AMENDMENT OF SOLICITATION/MODIFICATION OF CONTRACT			1. CONTRACT ID CODE		PAGE OF PAGES 1 6		
2. MODIFICATION NO.: 0007		3. EFFECTIVE DATE JAN 27, 2003		4. REQUISITION/PURCHASE REQ. NO. W81W3G-2035-7181		PROJECT NO. (If applicable)	
6. ISSUED BY Department of the Army Baltimore District, Corps of Engineers Contracting Division P.O. Box 1715 Baltimore MD 21203-1715		CODE CA31		7. ADMINISTERED BY: Contracting Division, Contracts Branch CENAB-CT-C 10 S. Howard ST. Room 7000 Baltimore, MD 21203-1715		CODE E1P0100	
8. NAME AND ADDRESS OF CONTRACTOR (No., street, county, State and ZIP Code)				(x)		9A. AMENDMENT OF SOLICITATION NO. DACW31-02-R-0044	
				X		9B. DATED (SEE ITEM 11) NOV 12, 2002	
						10A. MODIFICATION OF CONTRACT/ ORDER NO.	
						10B. DATED (SEE ITEM 13)	
CODE		FACILITY CODE

**BELL/LINCOLN MULTICULTURAL SCHOOL MODERNIZATION
WASHINGTON, DC**

AMENDMENTS:

DESCRIPTION:
SK-M-001

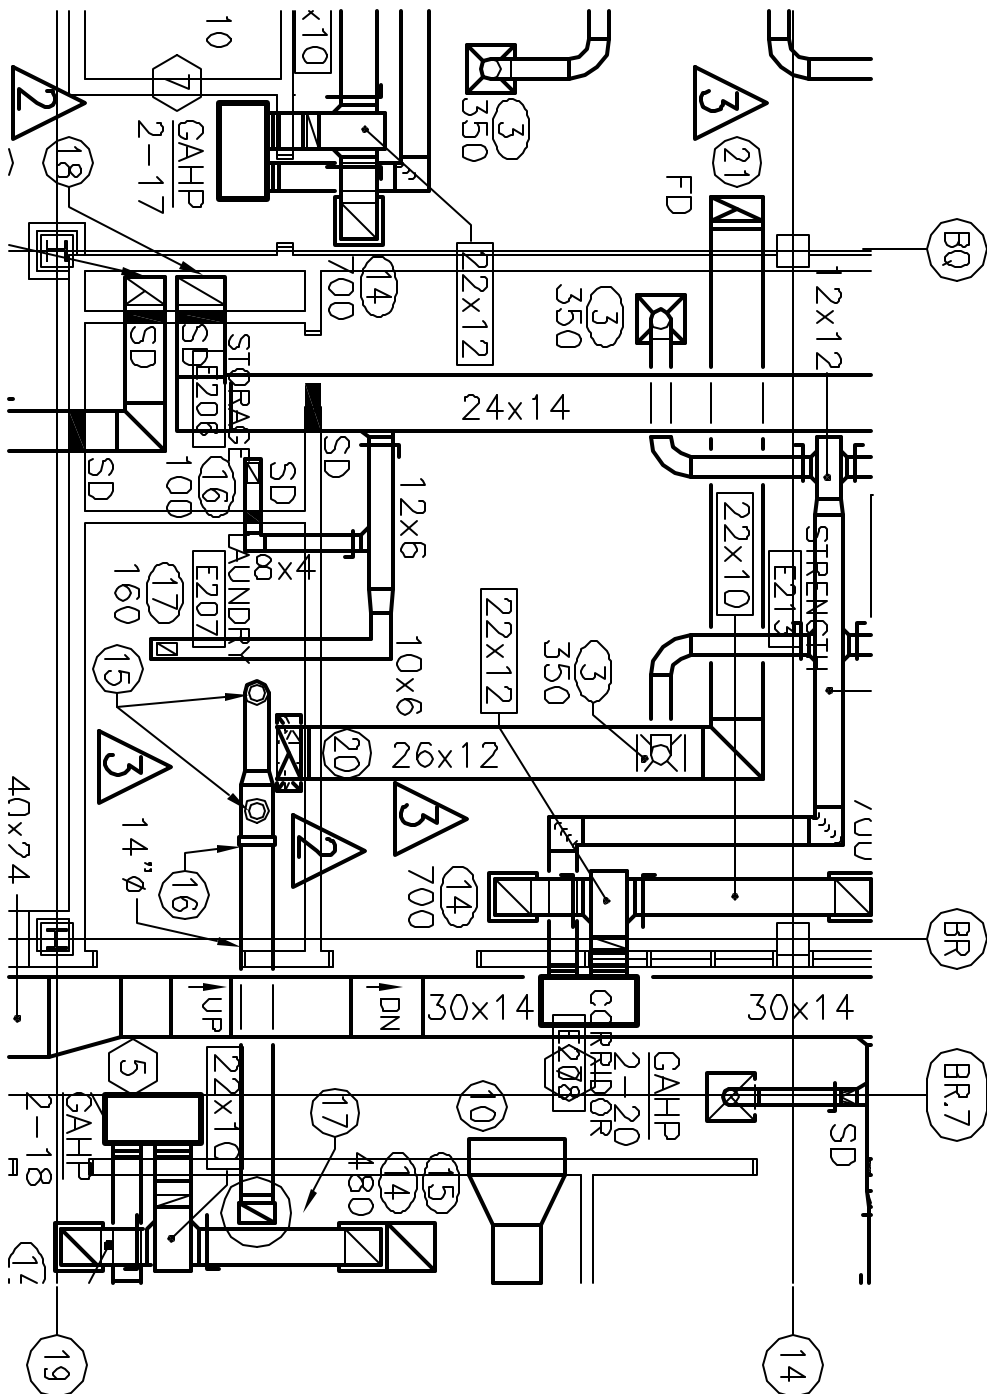
- g) Added some minor notes to ductwork serving Laundry E207. Changed dryer exhaust duct size from 16" diameter to 14" diameter. Placed duct size, 26x12, on combustion air duct.

- h) Revise this plate in accordance with the attached Sketch SK-M-001 dated 01/17/2003
- 15) AMENDMENT 0004, ITEM #43: Remove Drawing Note 13 and replace with: 5" diameter dryer exhaust duct up.

DESCRIPTION:
SK-M-002

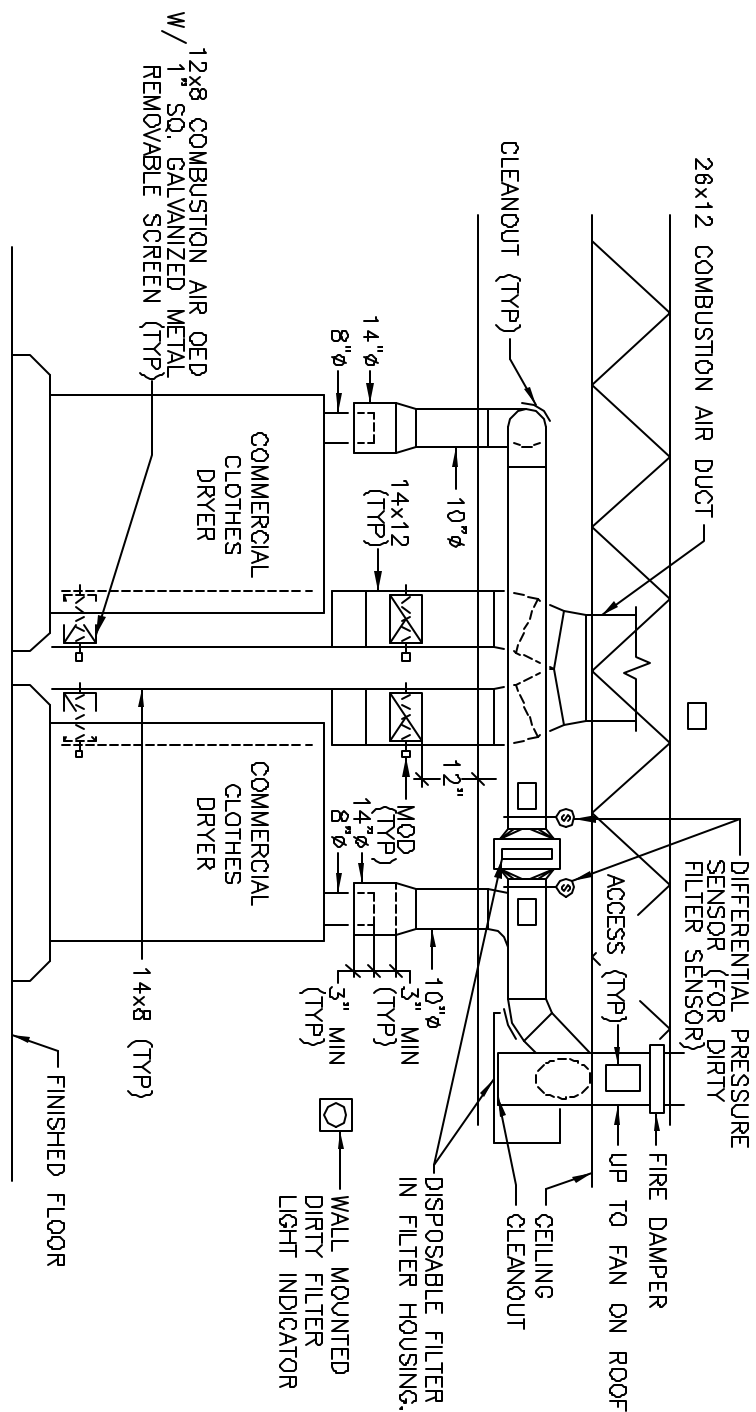
- 18) AMENDMENT 0004, ITEM #46: Remove Drawing Note 8 and replace with: 14" diameter dryer exhaust duct down.
- 19) AMENDMENT 0004, ITEM #51:
- a) Removed Detail C5 and replaced with a revised detail – "Gas fired commercial clothes dryer detail".

- d) Revise this plate in accordance with the attached Sketches SK-M-002 and SK-M-003 dated 01/17/2003.
- 20) AMENDMENT 0004, ITEM #55: Added Note 3 to GENERAL EXHAUST FAN SCHEDULE: "MOTORS FOR FANS GEF-9, 10, 11, 12 & 14 shall be located outside of the air stream."

DESCRIPTION:
SK-M-003

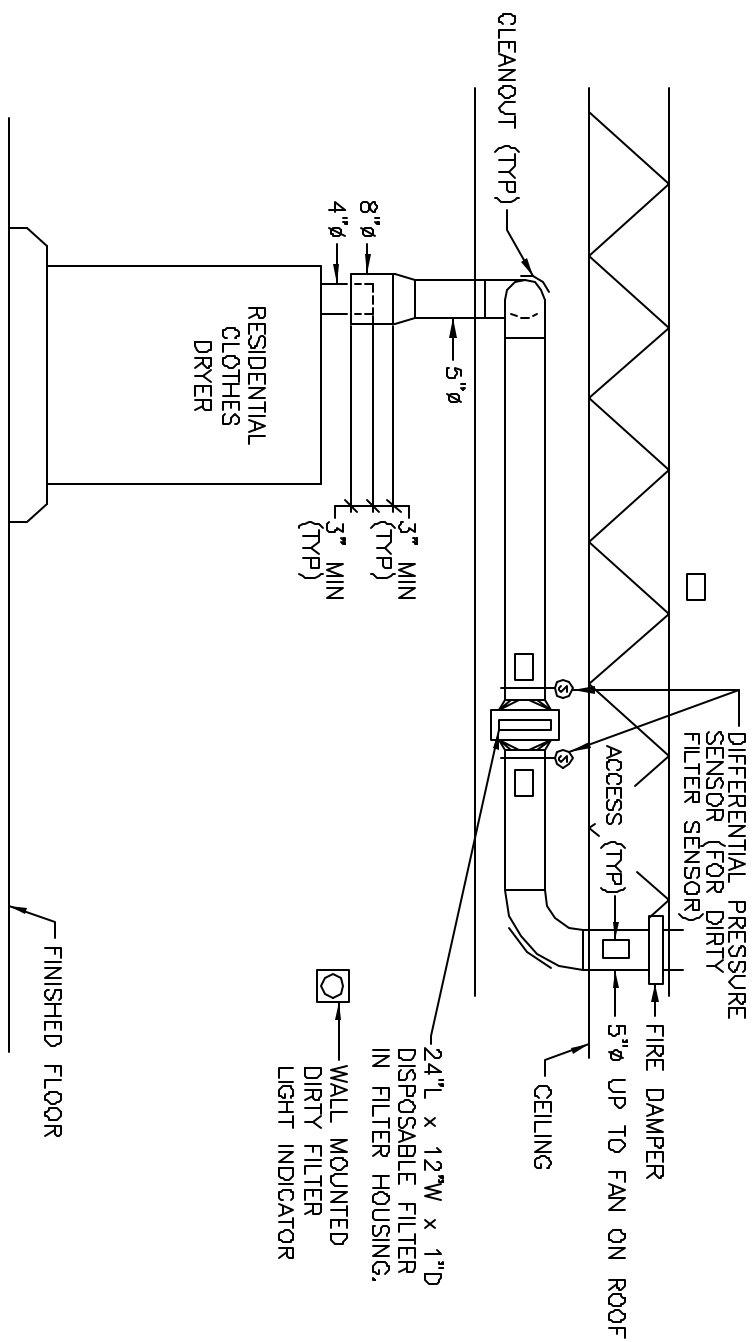
- b) Relabeled Detail B5 – "TYPICAL ROOF CURB PIPING PENETRATION DETAIL" as Detail B4.
 - c) Added Detail B5, "GAS FIRED RESIDENTIAL CLOTHES DRYER DETAIL."
